## Query Clarification

### **Inquiry Number 91086917, Tender for supply of Grey Cast Iron Receiver.**

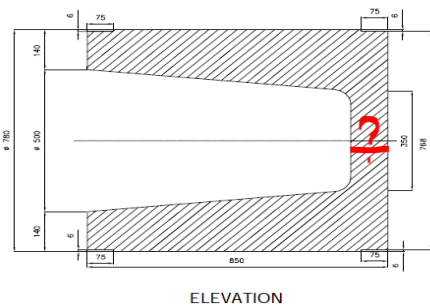
**Question 3:** The highlighted dimension is missing. Kindly Clarify.

**Answer 3:** Please refer the revised enclosed drawing with dimensions updated. The missing dimension is 75mm.
